Cutblock discussions and verification of landforms were originally conducted during a field trip on October 8, 2015 by RDI with BCTS, and field resource people in attendance. RDI produced a VIA report based on those discussions. A revised proposal was received from BCTS in 2018. This visual assessment considers each and all of the proposed cutblocks. RDI was not provided the opportunity to assess Viewpoints 1 through 9 on-site and cannot verify the accuracy of the simulations from those viewpoints. On-site validation is recommended to determine roadside screening from all viewpoints.

Ken B. Fairhurst, PhD, RPF
RDI Resource Design Inc
July 27, 2018

Summary of Cutblock / Landform Findings

Albreda 2018 - VP 4-1729D

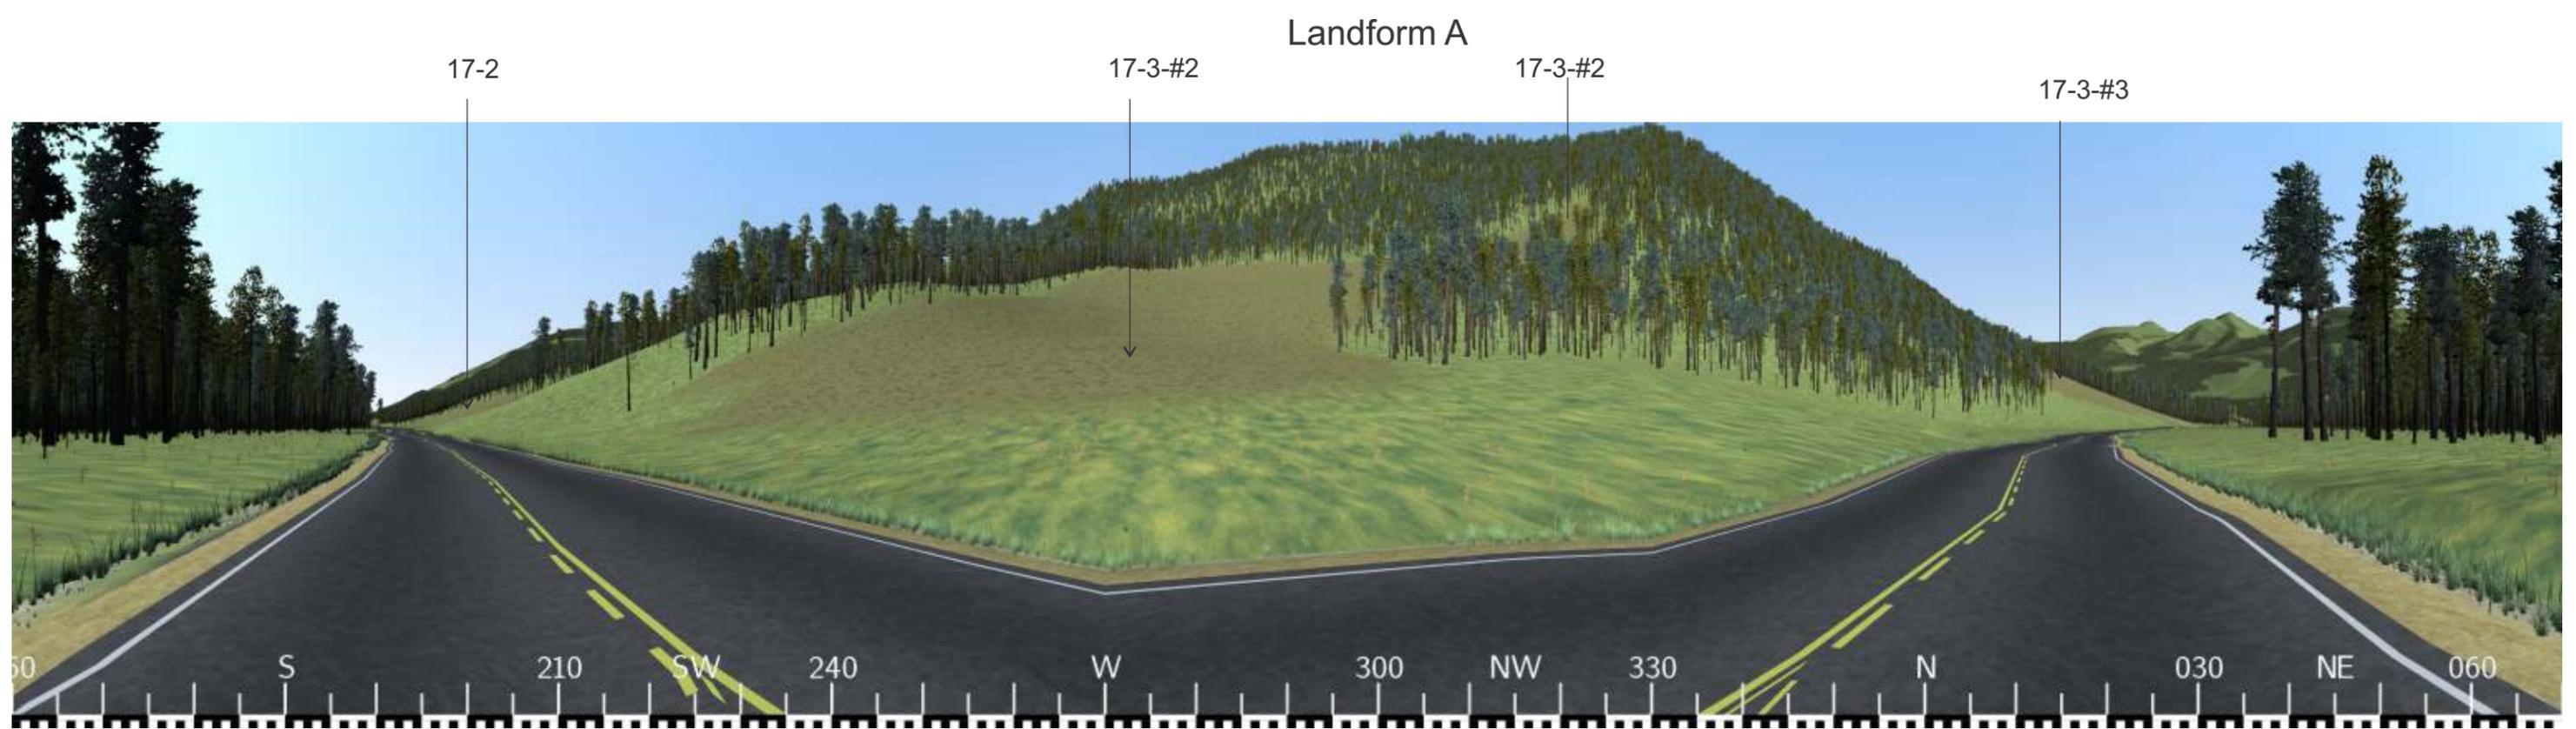
Percent Alteration Viewpoint 4		
NAME	AREA2	% Alt
Landform A	1380166.09	
17-3*	301566.51	21.85%
17-3	1607.26	0.12%
17-3	1709.93	0.12%
17-3	572.08	0.04%
17-3	6420.35	0.47%
17-3	228.52	0.02%
17-2	3639.72	0.26%
Sum Landform A*	315744.38	22.88%
*Scale is excessive. Requires on-site review of roadside screening to determine cutblock visibility.

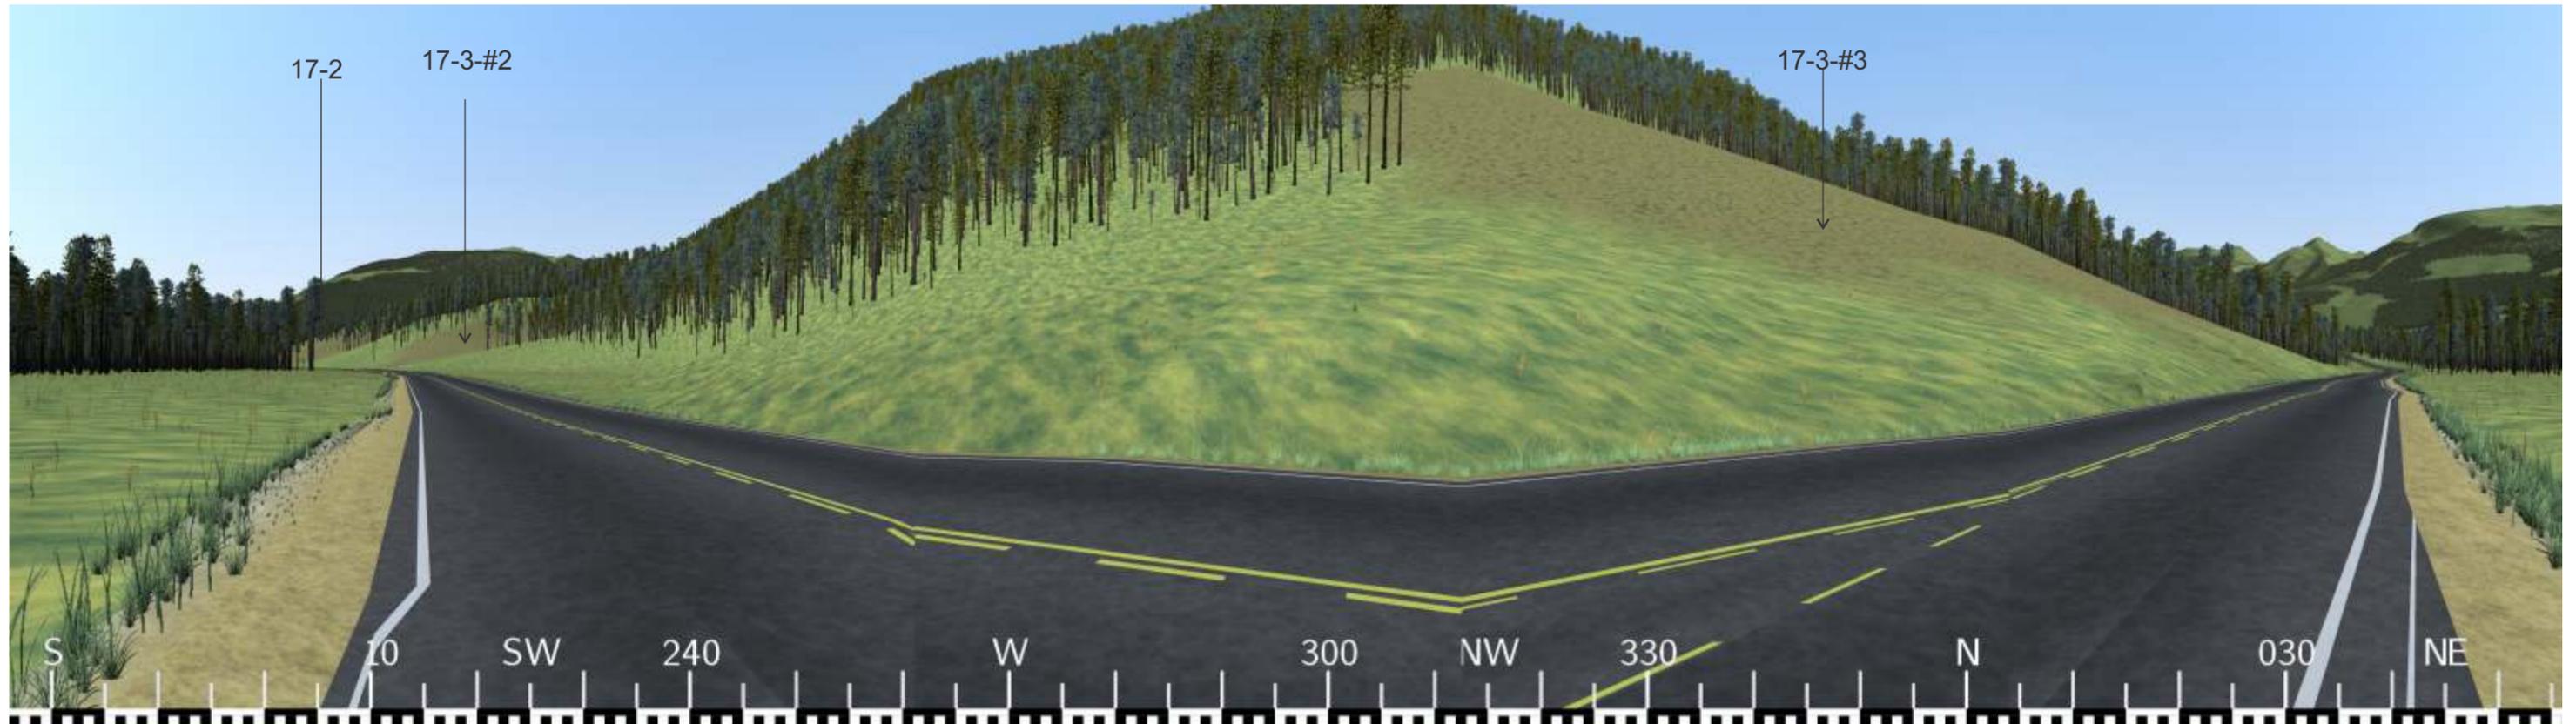
Percent Alteration Viewpoint 5		
NAME	AREA2	% Alt
Landform A	1997718.07	
17-3*	235574.18	11.79%
17-3	17093.73	0.86%
17-2	4307.96	0.22%
Viewpoint 5 Sum*	256975.87	12.86%
Percent Alteration from Viewpoint 5 exceeds limit of 7% for Partial Retention VQC. Requires site visit to determine extent of roadside screening.

Albreda 2018 - VP 7-1730.2

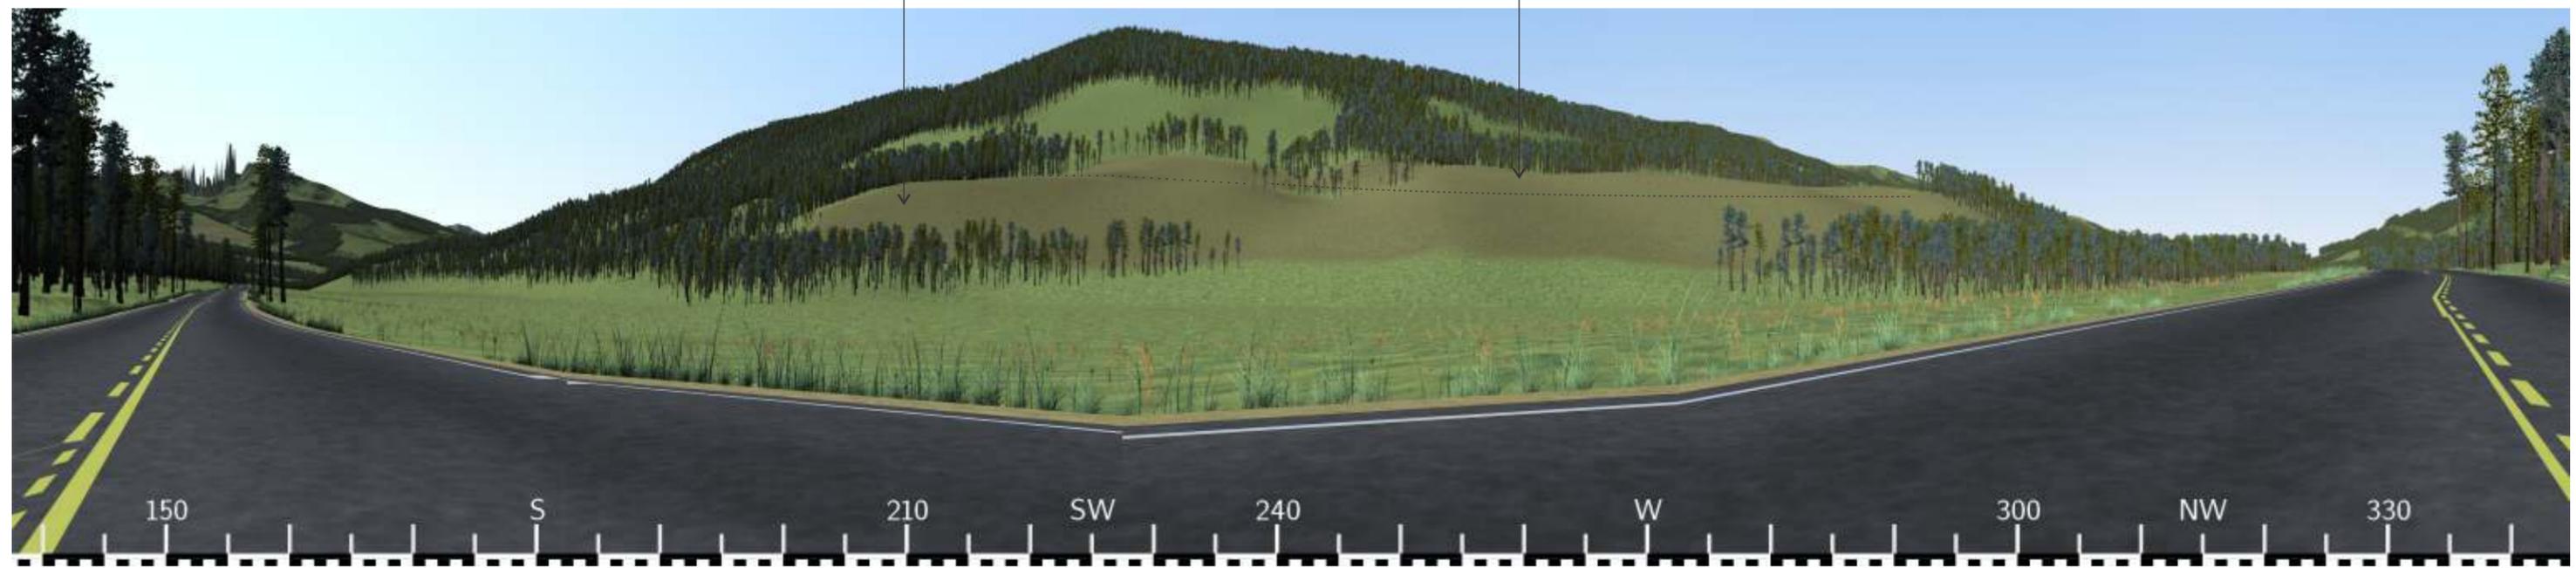
Percent Alteration Viewpoint 7		
NAME	AREA2	%Alt
Landform A	1212194.04	
17-1*	257886.47	21.27%
18-5	38686.24	3.19%
18-5	982.16	0.08%
Sum Landform A*	297554.86	24.55%
*Greatly exceeds PR VQO. On-site review of roadside screening required.

Albreda 2018 - VP 10 - 1734/275 - Snowmobile Lot - Percent Alteration

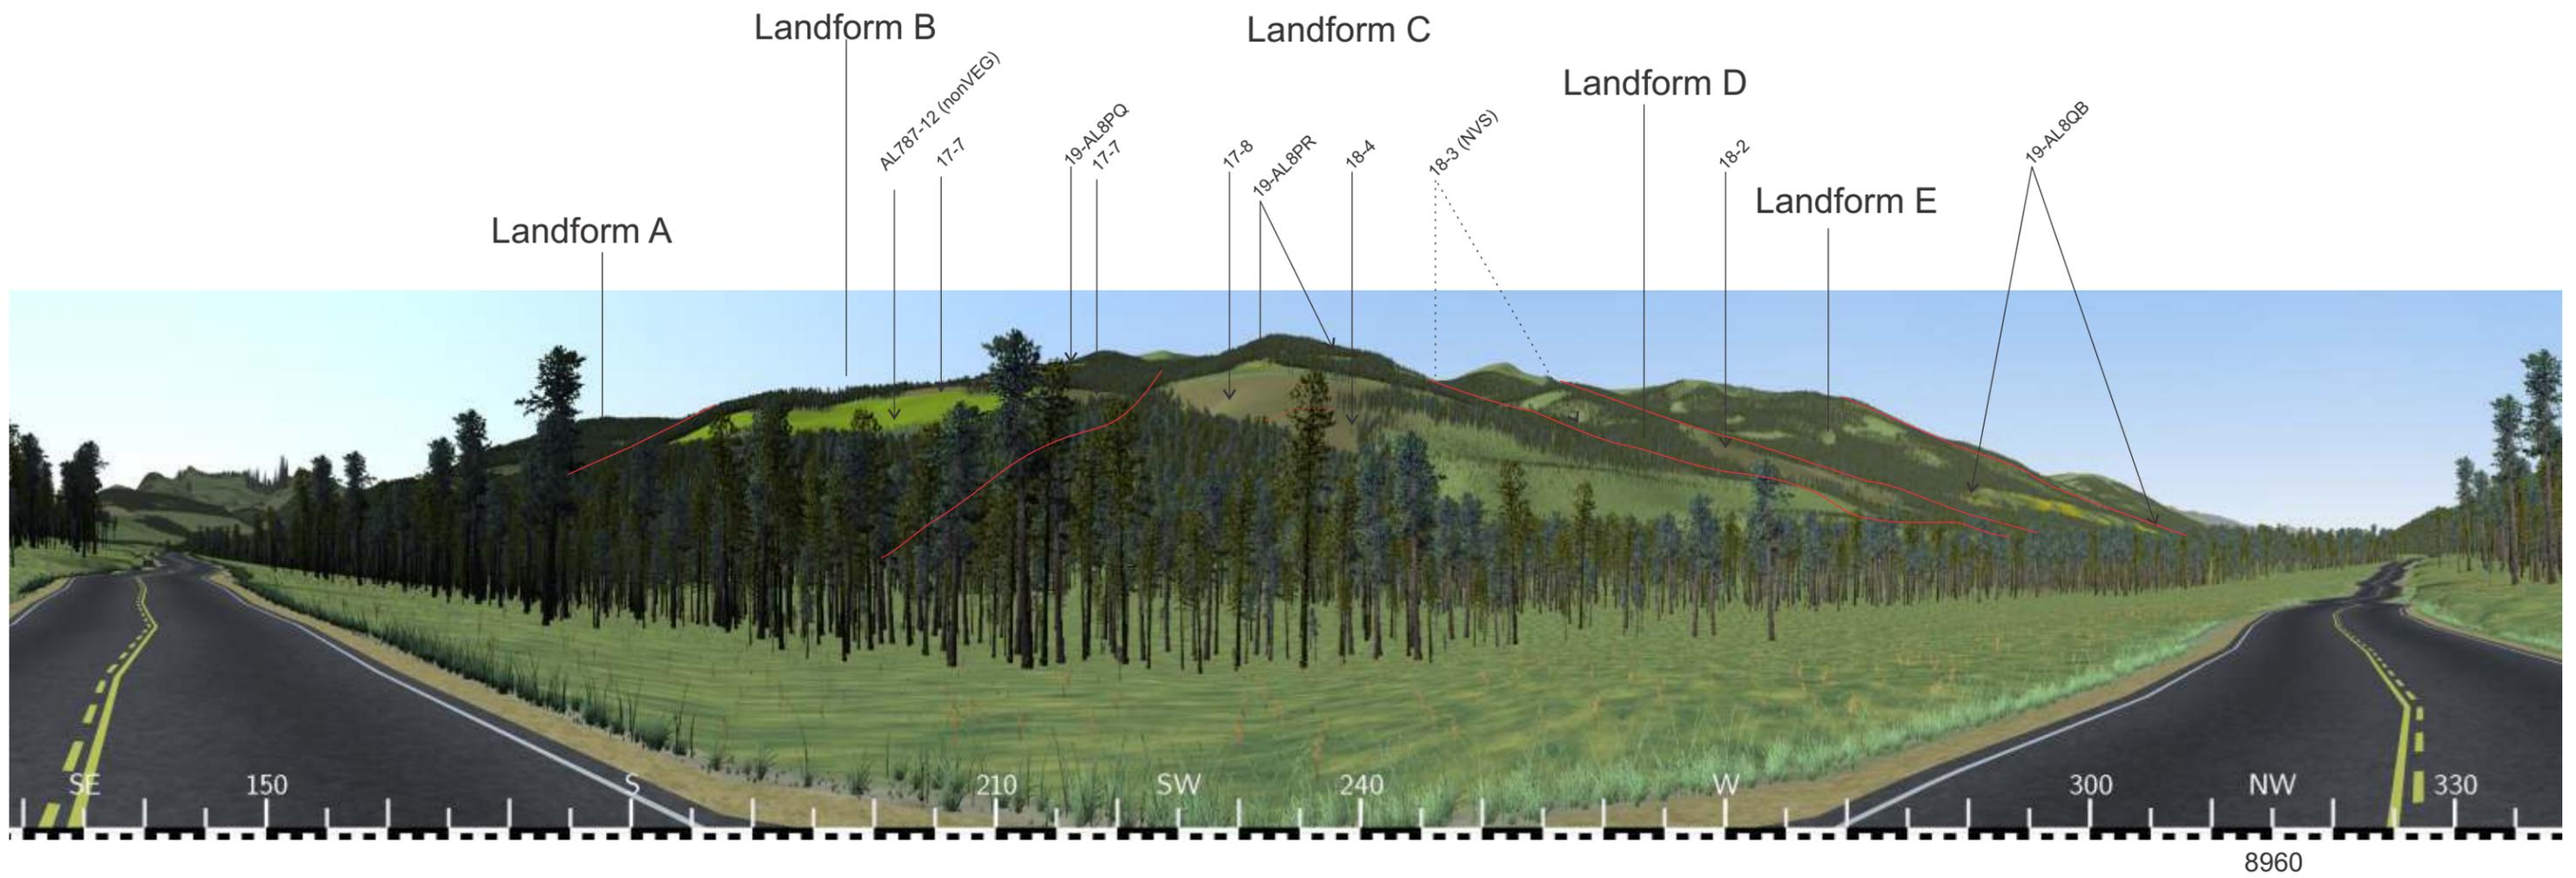
*Landform C is narrow in this oblique view towards it. Cutblock 17-8 in Landform C is 9.87% alteration, exceeding the VQO of Partial Retention. See Viewpoint 11 for more direct view of Landform C (3.8% Alteration). Combining Landforms B and C together for purposes of percent alteration calculation brings overall B&C percent alteration well within the limits of Partial Retention VQC.

See notes regarding 17-8 in Landform C in the Percent Alteration page for Viewpoint 11

Albreda 2018 - VP 11 - 1733.1 - Percent Alteration

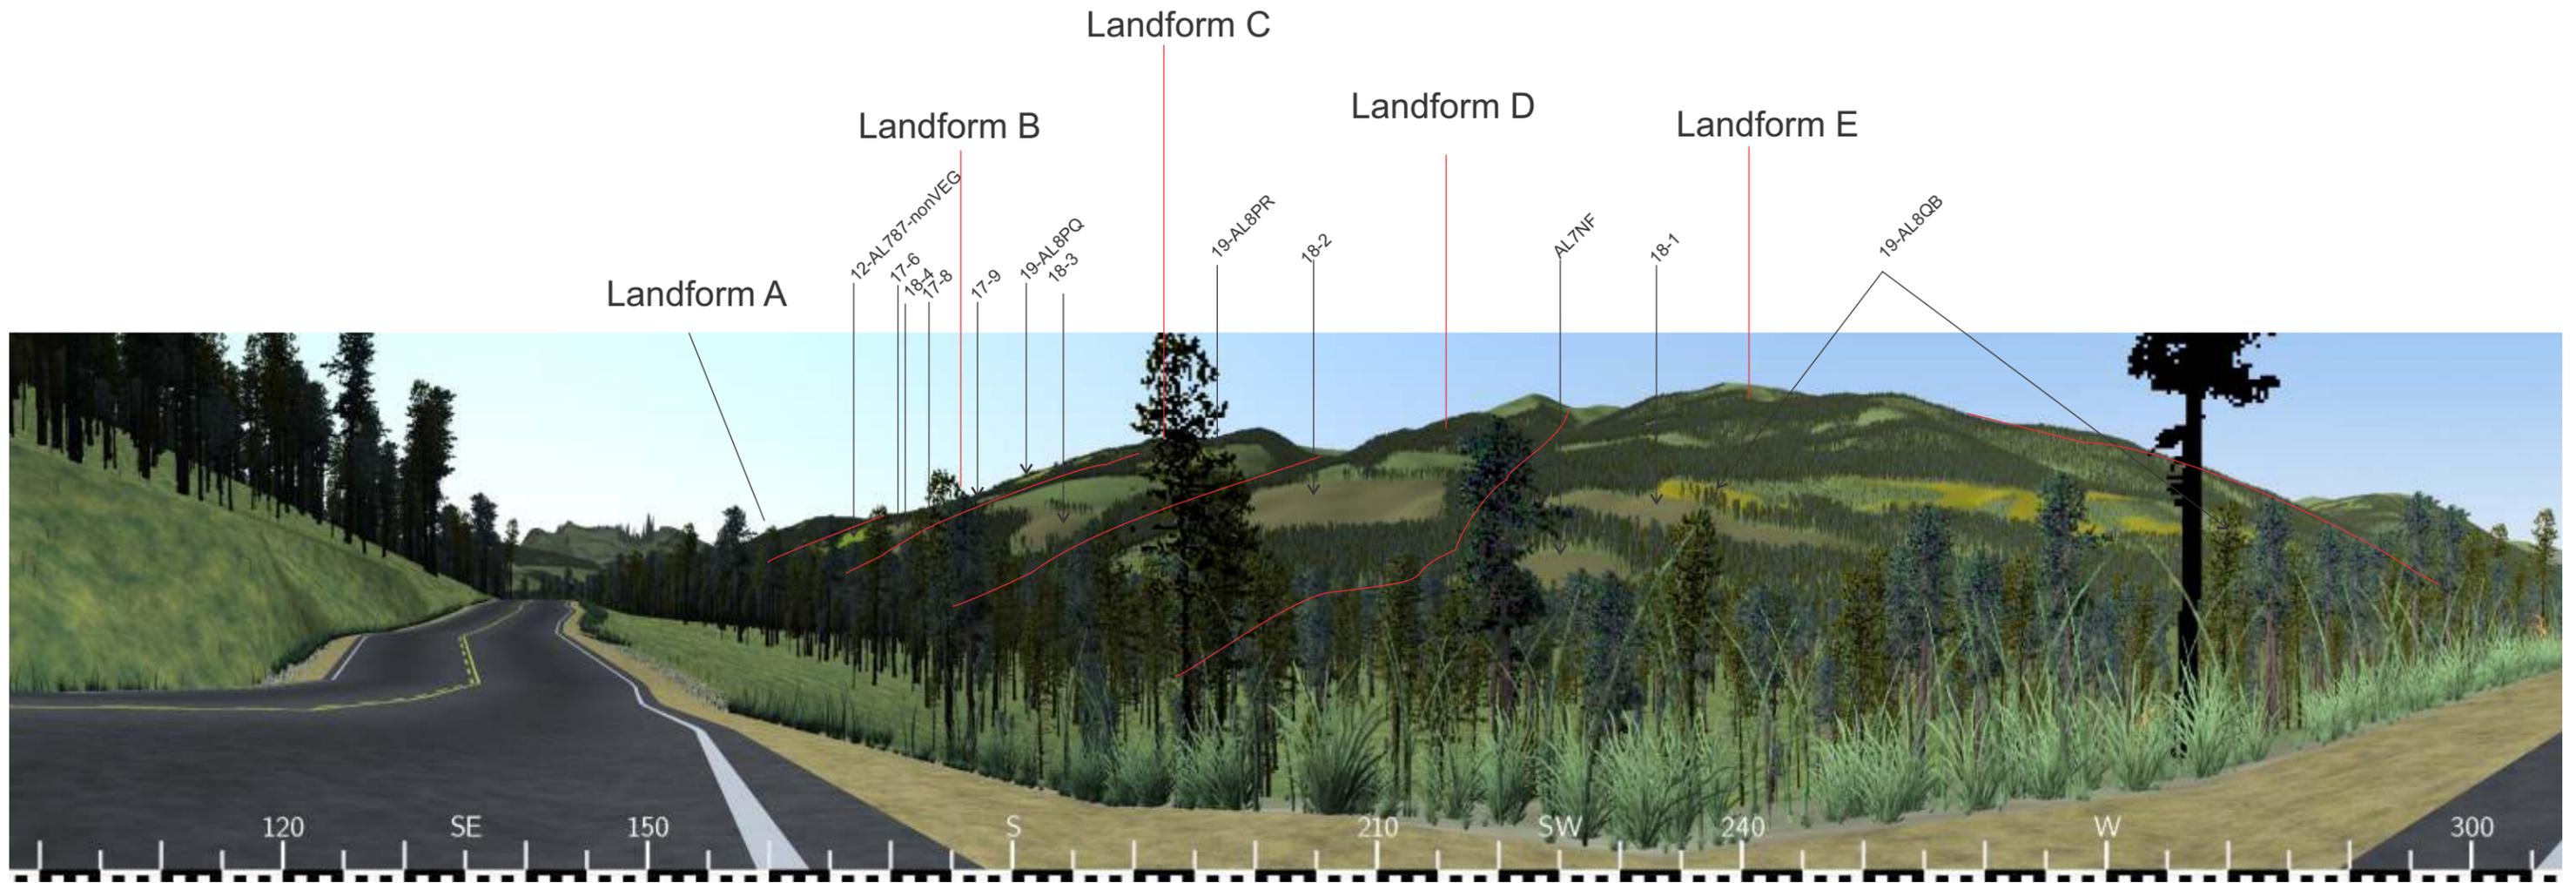
*Landform D is narrow in this oblique view towards it. See Viewpoint 12 for a more direct view of Landform D (8.7% alteration in from VP 12 vs 9.8% alone in Viewpoint 11 - indicating VQO exceeded from both viewpoints). Combining Landforms C and D together for percent alteration calculation brings overall C+D percent alteration well within the limits of Partial Retention VQC. However, individual numbers suggest reduction in scale of 18-2 with in-block tree retention is indicated.

Landform C meets the Percent Alteration limits with a combined 3.8%. However, the concentration of all of the alteration into the upper part of the landform, and all directly adjacent to each other causes the total alteration to look moderate to large in scale. Consider some leave patches to break up the concentration somewhat, mainly in 17-8. This should help the appearance of 17-8 in Viewpoint 10.
